CONTRACT NO. DE-AC27-01RV14136 – TRANSMITTAL OF U.S. DEPARTMENT OF ENERGY, OFFICE OF RIVER PROTECTION (ORP) DESIGN OVERSIGHT REPORT ON HIGH LEVEL WASTE (HLW) VITRIFICATION FACILITY TREATMENT CAPACITY, D-04-DESIGN-008

**Waste Treatment Plant
HLW Vitrification Facility Treatment Capacity**

D-04-DESIGN-008

Figure D.2 Calculated Canister Heat Release Rates during Pouring and Initial Cooling

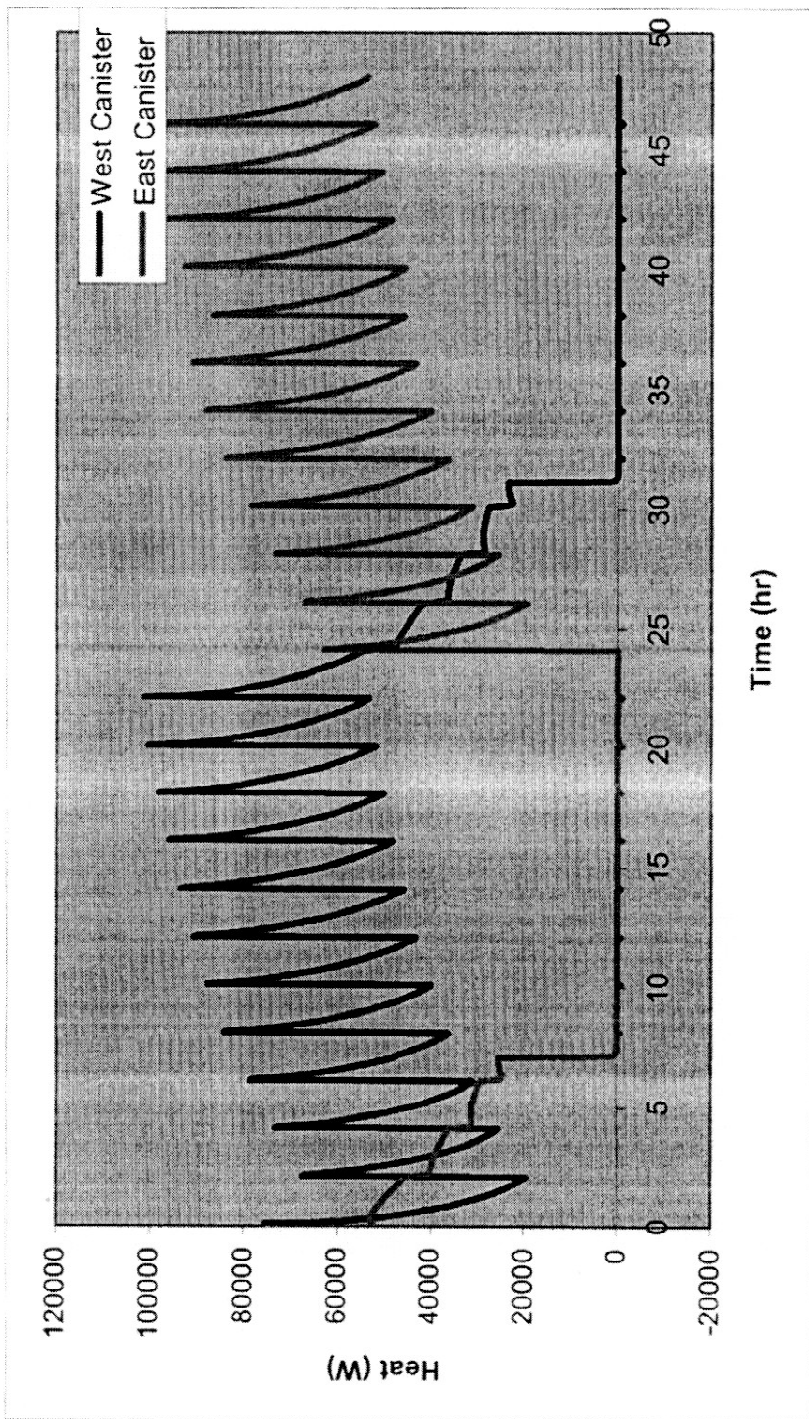
The CFD analyses were performed for the canister temperatures associated with 24 hour pour period. During the pour period radiation is an important factor in calculating the temperature on the insulation at the walls, ceiling and floor. It is likely that the temperatures on the canister surface may be higher during a 20 hour versus a 24 hour pour period. The low conductivity of the glass, however, would tend to minimize the differences. A new CFD analysis would be required to verify that the insulation thicknesses are adequate to maintain the concrete and structural temperatures within design limits. It is judged, however, that these analyses would show that the temperatures are acceptable.

It is concluded, therefore, that the pour cave ventilation system is adequate to support a melter production rate of ~3.6 MTG/day to 3.75 MTG/day that would be required to achieve the ORP Stretch Goal net production rate of 615 canisters per year (assuming a 72% HLW facility availability).

Figure D.3 Estimated Times to Complete Principal Finishing Line Functions

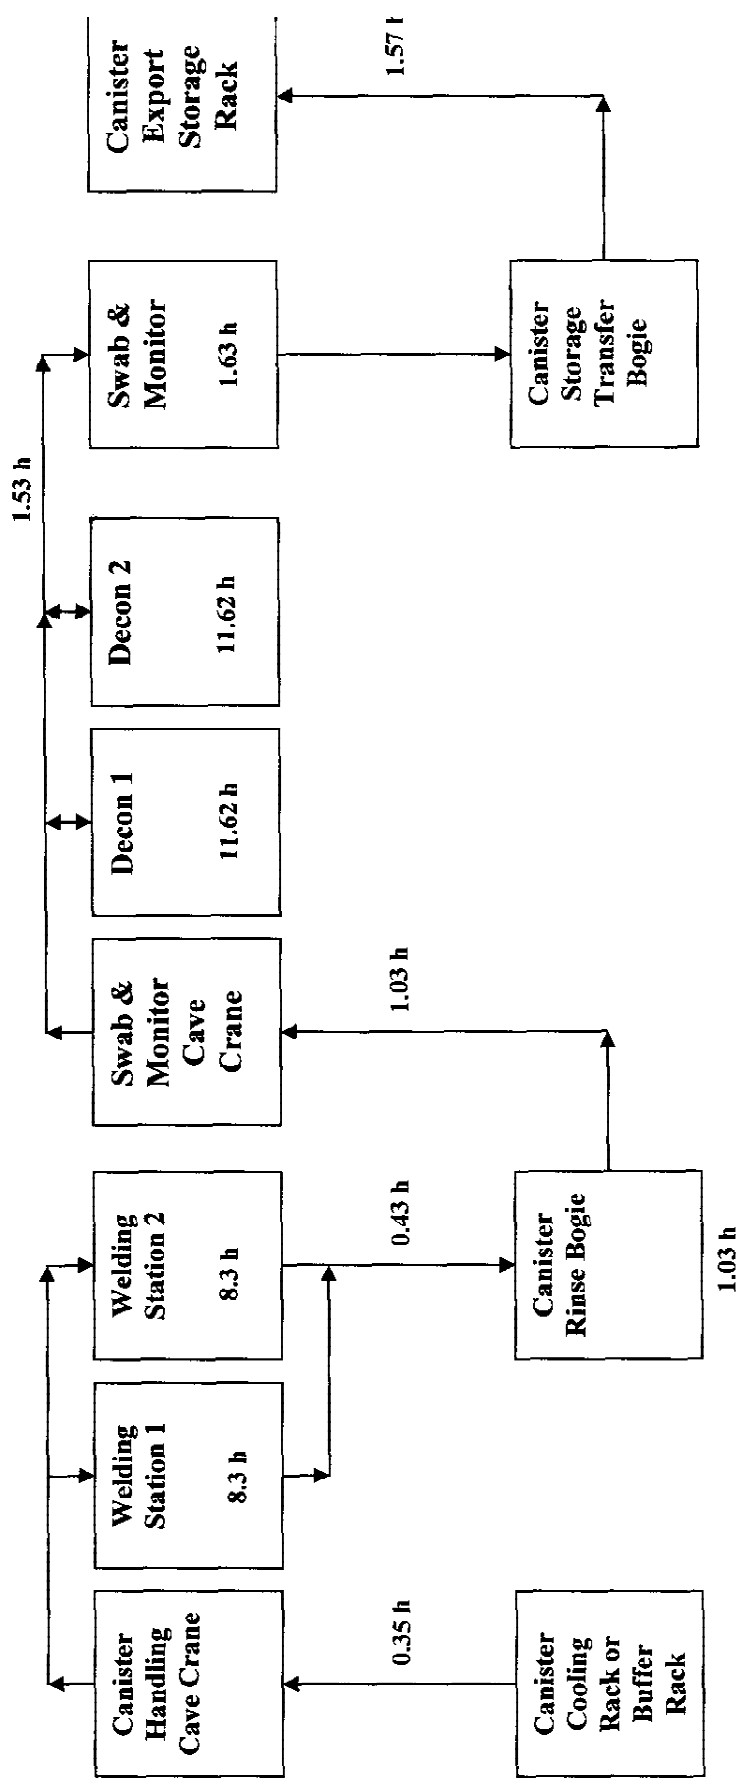
Figure D.3 shows the estimated times for completion of each of the major evolutions in the canister finishing line including removal of a canister from the cooling racks through transfer to the canister export storage racks. Note that there are four major stations:

Figures D.1 and D.3 show that the single failure vulnerabilities in the canister handling systems are:
